## TOSHIBA Microcontrollers TX03 Series

TMPM330FDFG    TMPM330FYFG    TMPM330FWFG

### Restrictions on Consumer Electronics Control (CEC)

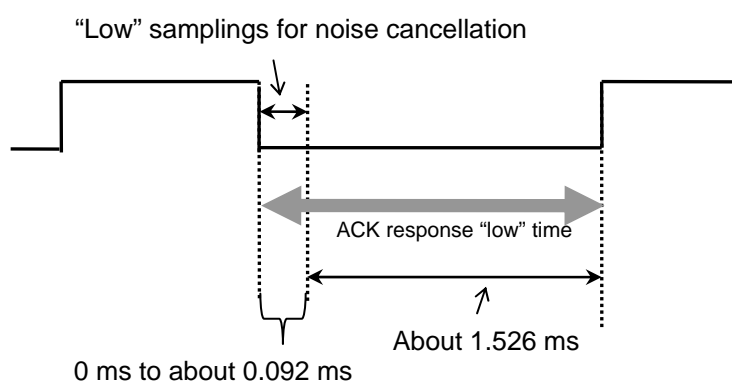
Restrictions are applied when the “low” samplings for noise cancellation, CECRCR1<CECLNC>, is used as the CEC function.

1. Set the same values to both “low” samplings for noise cancellation CECRCR1<CECLNC> and the rising timing of data bit CECTCR<CECDTRS>.
2. Set the values of “low” samplings for noise cancellation CECRCR1<CECLNC> between “000” and “011”.

## 2. "Low" output timing when a minimum cycle error occur

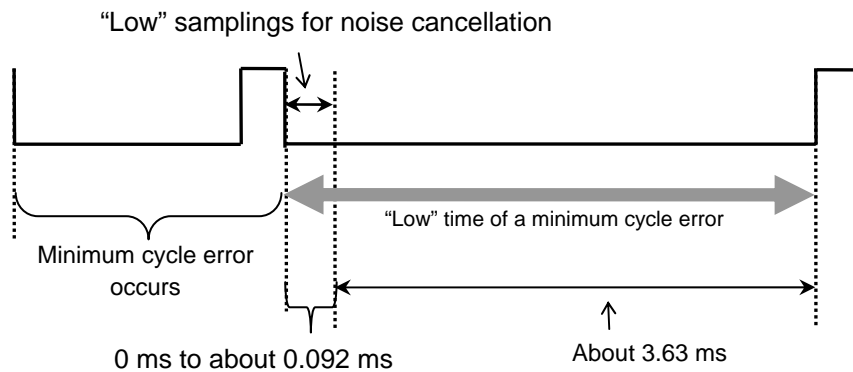
"Low" output timing when a minimum cycle error occurs is as shown below.

Minimum cycle error "Low" time = ("Low" samplings for noise cancellation) + (Base time: 3.63ms)

When a minimum cycle error occurs, "low" signal is output (about 3.63ms) after the elapse of "Low" samplings for noise cancellation.

#### □ Corrections on the page of CECRCR1 (Receive control Register 1)

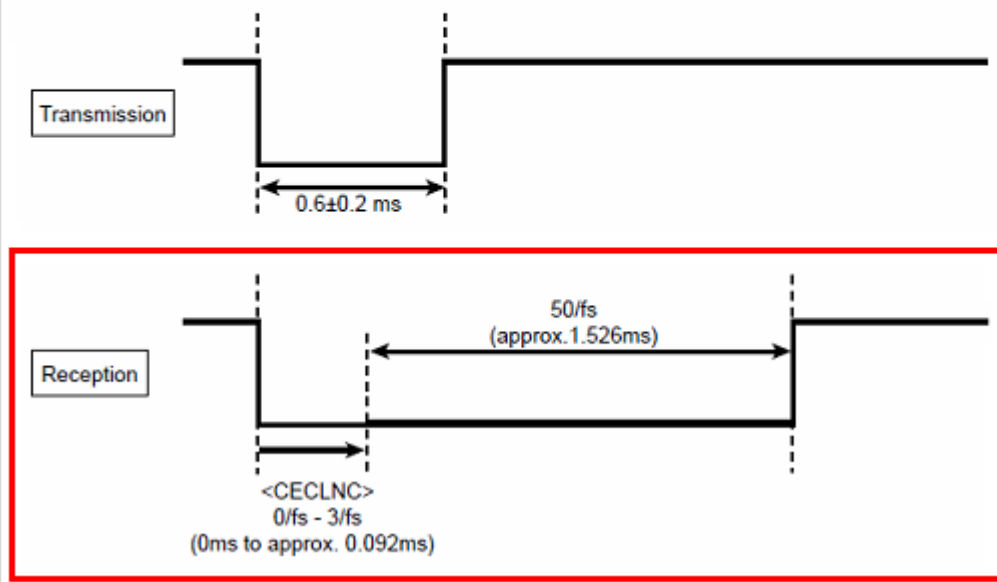
1. The following part has been deleted:  
A setting example when the "low" samplings for noise cancellation <CECLNC> are 4/fs (five consecutive fs clocks observed) or higher.
2. A note was added as follows: Use <CECLNC> with the same settings with CECTCR<CECDTRS>.

1. The following part has been deleted:

2. A note was added as follows: Use <CECDTRS> with the same settings with CECRCR1<CECLNC>.

**Note 4: <CECLNC> must be used under the same setting as CECTCR<CECDTRS>.**

Note: <CECDTRS> must be used under the same setting as CECRCR1<CECLNC>.
